Change No. 8

Your letter dated July 5, 1973 enclosed proposed Technical Specification Change No. 8, which supersedes your proposed Technical Specification Change No. 8 requested in your letter of June 4, 1973. The proposed changes are required in order to implement a reduced primary system pressure program to preclude fuel collapse during the first fuel cycle.

We have reviewed the report "Fuel Densification - Surry Units 1 and 2 - Low Pressure Analysis," dated April, 1973, concerning the reduction of the primary system pressure in order to reduce the clad creep rate. On the basis of our review, we have determined that the three areas requiring assessment were DNB, stored energy and creep collapse. The DNB analysis was performed using the methods as described in the FSAR. The methods are equally valid at the lower pressure since the experimental data base included the lower pressure. The staff concludes that the DNB margins are similar to those at high pressure because the coolant temperatures are reduced accordingly. For determining the stored energy only, the low pressure creep rate was used. This increases the stored energy and therefore, is conservative and acceptable. A reduc

Figure 2.1-2. Reactor Core Thermal and Hydraulic Safety Limits, Two Loop Operation, Loop Stop Valves Open

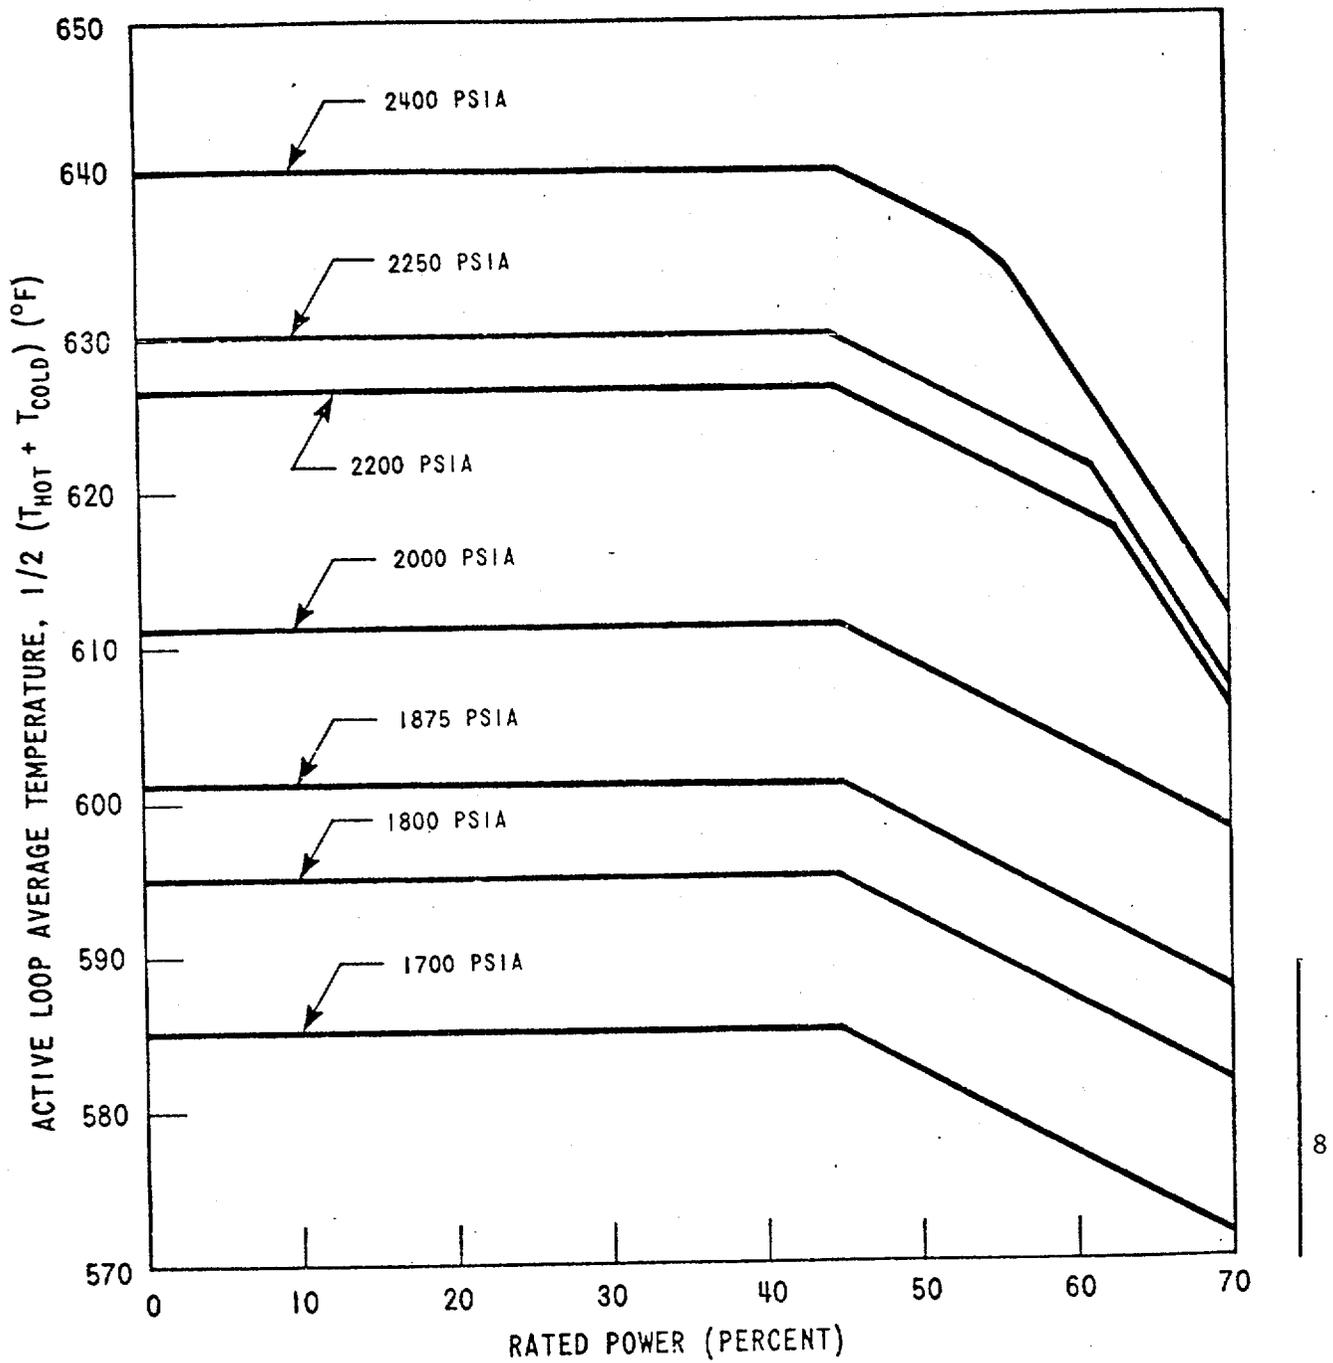
Accordingly, pursuant to Section 50.59 of 10 CFR Part 50, the Technical Specifications of Facility Operating License Nos. DPR-32 and DPR-37 are hereby changed as follows: replace pages TS Figure 2.1.1, TS Figure 2.1.2, TS Figure 2.1-3, TS 2.3-1, TS 2.3-2, TS 2.3-5, TS 2.3-6, TS Figure 3.12-1, and TS Figure 3.12-2 with the revised pages (designated as Change No. 8 on the bottom of the page) TS Figure 2.1-1, TS Figure 2.1-2, TS Figure 2.1-3, TS 2.3-1, TS 2.3-2, TS 2.3-5, TS 2.3-6, TS Figure 3.12-1, and TS Figure 3.12-2 enclosed.

The overpower and overtemperature protection system setpoints have been revised to include effects of fuel densification and reduced pressure operation on core safety limits. The revised setpoints in the Technical Specifications will ensure that the combination of power, temperature, and pressure will not exceed

the revised core safety limits as shown in Figures 2.1-1, 2, and 3.
